**BROWNS FERRY NUCLEAR PLANT (BFN) - UNITS 1, 2, AND 3 -
SEQUOYAH NUCLEAR PLANT (SQN) - UNITS 1 AND 2 -
REQUEST FOR NRC REVIEW AND APPROVAL OF COST BENEFICIAL
LICENSING ACTION - PROPOSED EMERGENCY PLAN CHANGE -
CORE/THERMAL HYDRAULIC ENGINEER STAFF AUGMENTATION**

OPERATING AND MAINTENANCE COST REDUCTION PROGRAM
COST BENEFICIAL LICENSING ACTION
CHANGE TO EMERGENCY PLAN STAFFING REQUIREMENT
CORE/THERMAL HYDRAULIC ENGINEER STAFF AUGMENTATION

MARKED-UP BFN AND SQN REP
FIGURE A-1
SITE EMERGENCY ORGANIZATION

**FIGURE A-1
SITE EMERGENCY ORGANIZATION**
(Including Minimum Staffing and Staff Augmentation)

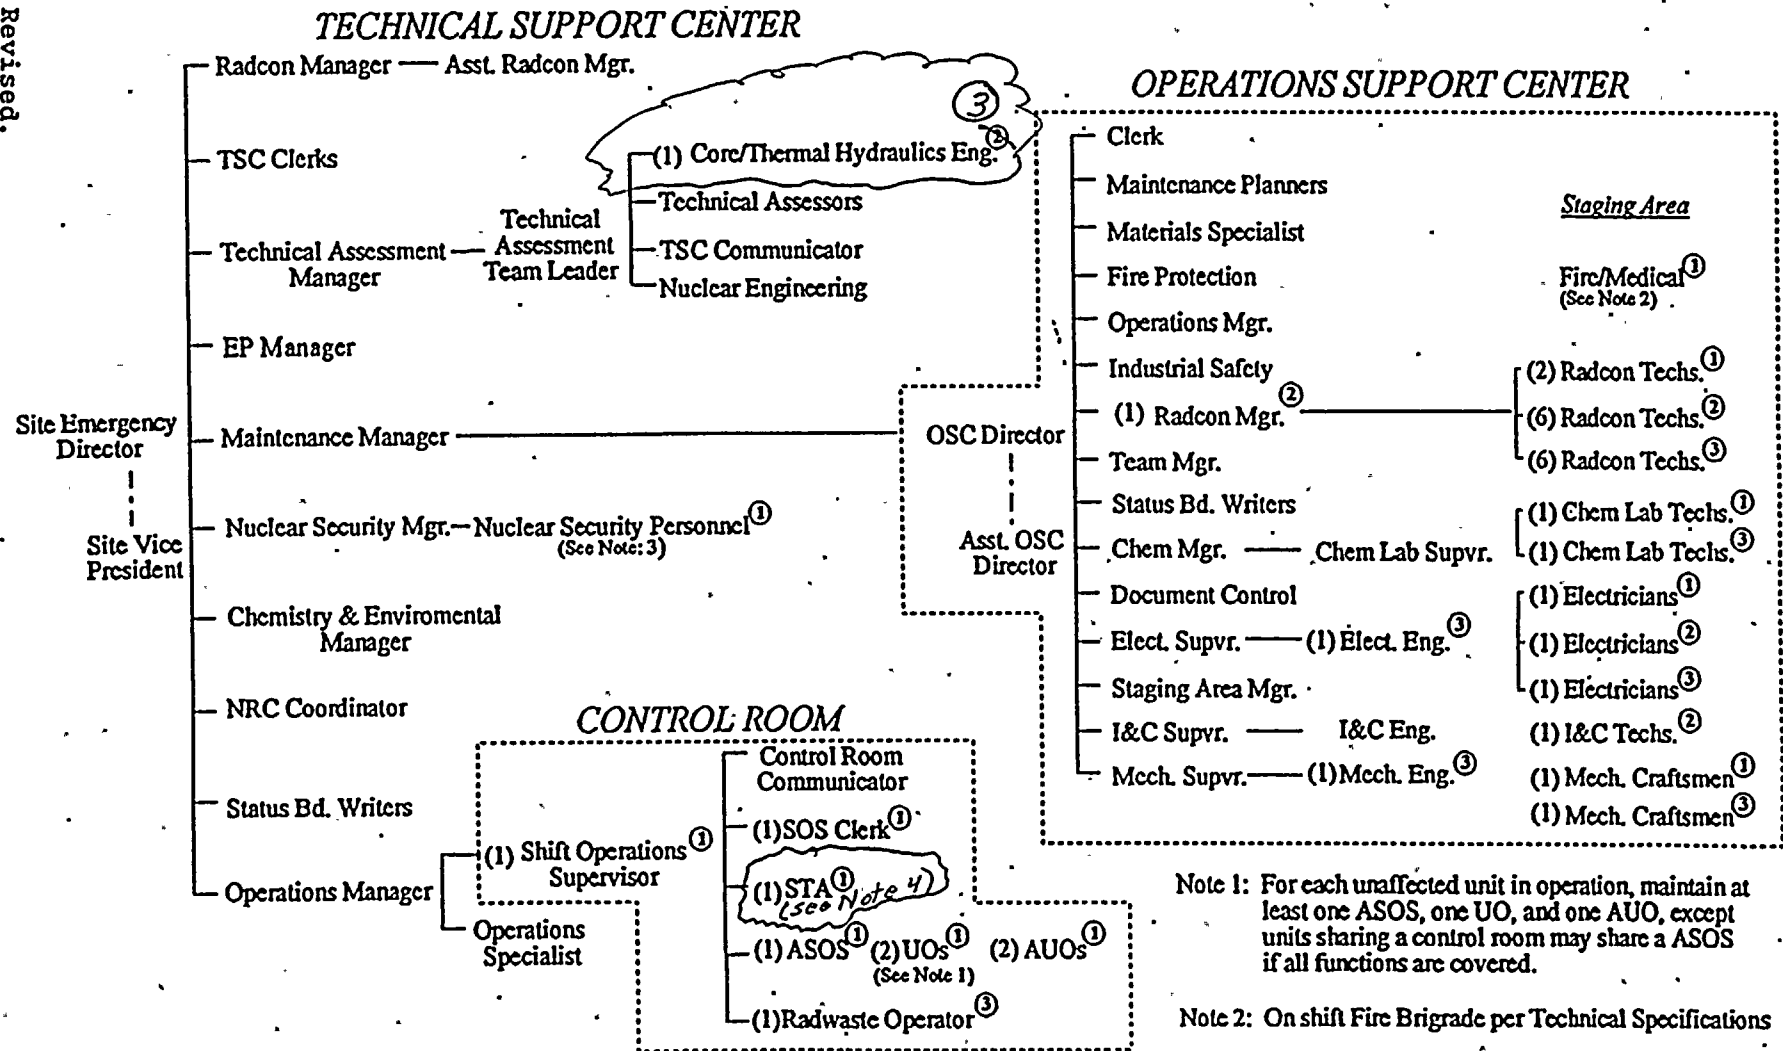
In order to maintain consistency throughout TVA's nuclear units, the 30 minute staffing requirement will also be revised for SQN. Enclosure 1 provides a detailed discussion to support TVA's request. Enclosure 2 provides a marked-up copy of BFN REP Table A-1, "Site Emergency Organization," and SQN REP Figure B-1, "Technical Support Center Emergency Preparedness," to show the proposed change. There are no commitments made in this letter. If there are any questions regarding this submittal, please telephone me at (615) 751-2687.

Pursuant to the requirements of 10 CFR 50.54(q), TVA requests approval of a change to the current REP requirement that supplemental core/thermal hydraulic engineering support be available to augment the on-shift staff within 30 minutes. TVA proposes to change the staff augmentation requirement from 30 to 60 minutes and denote that the STA is responsible for performing core/thermal hydraulic assessments during the first 60 minutes of an emergency. Enclosure 2 provides marked-up copies of BFN Figure A-1, "Site Emergency Organization," and SQN Figure B-1, "Technical Support Center Emergency Preparedness," to show the proposed change.

Note 1: For each unaffected unit in operation, maintain at least one ASOS, one UO, and one AUO, except units sharing a control room may share a ASOS if all functions are covered.
 Note 2: On shift Fire Brigade per Technical Specifications
 Note 3: On shift Security Personnel per Security Plan
 Note 4: Assumes Responsibility for Core/Thermal Hydraulic Assessment function During First 60 minutes of Event
